Docket Item # 6 & 7  
BAR CASE # 2013-0090/0091

BAR Meeting  
May 1, 2013

**ISSUE:** Permit to Demolish/Encapsulate and Alterations

**LOCATION:** 1 Prince Street

**Figure 1. The East Elevation of the Strand Building from Waterfront Park showing the proposed balcony location and the existing balcony on the building at the north end of the row.**

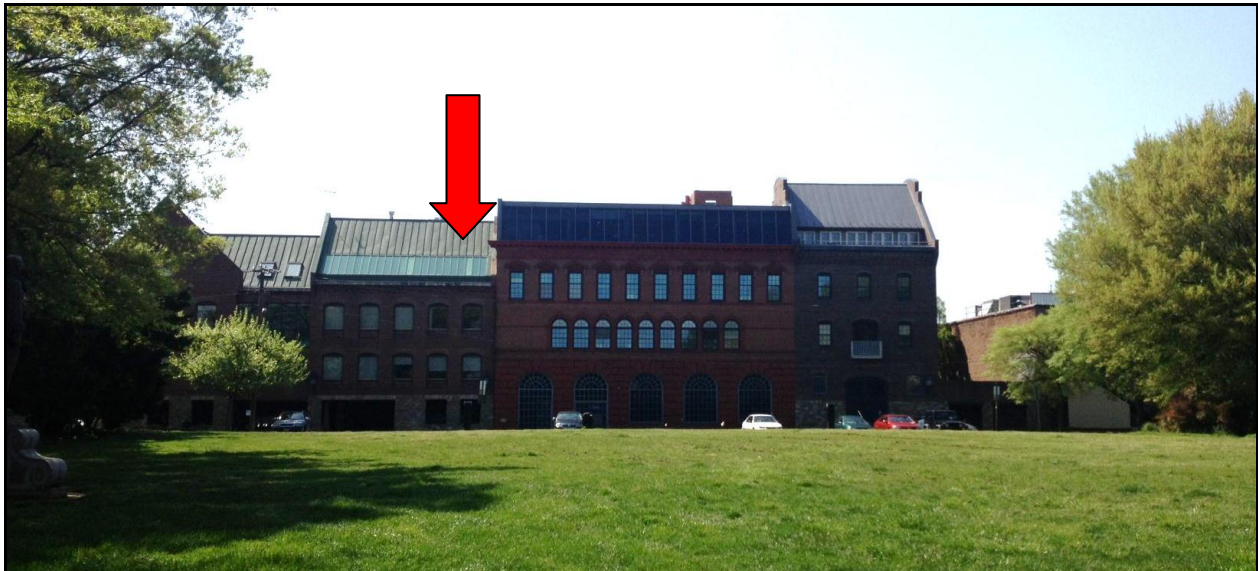
Staff recommends approval of the Permit to Demolish/Encapsulate and the Certificate of Appropriateness for alterations, with the condition that the balcony opening in the roof align with the brick piers and punched openings on the lower floors of the east facade.

In the opinion of Staff, none of the criteria for demolition and capsulation are met and the Permit to Demolish/Capsulate should be granted. The area proposed for demolition is not historic and the demolition will not compromise the overall integrity of the building. Although the area proposed is visible from the adjacent park, the area of impact is relatively small within the larger building mass.

However, the specific location of the balcony – driven primarily by the interior layout – does not relate to the regular symmetrical bays of the fenestration on the brick building below, making it look like an afterthought.

Staff recommends approval of the new balcony, provided that the width of the balcony is adjusted very slightly to align with the brick piers and punched windows on the floors below, so that it looks like it was designed as an integral part of the original building.
